Re: Item 4, 94244

From: [Carrie Rothburd](#)
To: [Urban Design Comments](#)
Subject: Please post to Legistar for UDC 8/19/26, Item 4
Date: Wednesday, August 19, 2026 4:29:03 PM

Date: August 19, 2026
To: Urban Design Commission
From: Alex Saloutos
RE: **Legistar File 94244, 222 East Olin Avenue, Informational Presentation, Urban Design District 1**

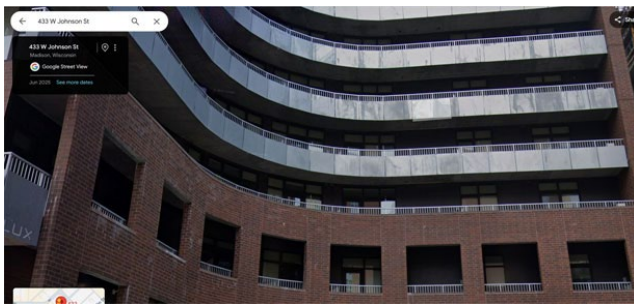
2) Metal corrodes. The shiny metal panels used on The Lux. at 433 W. Johnson developed a mottled and corroded-looking patina within the first year of their installation. I have attached a picture of the Lux to this email and also include it here.
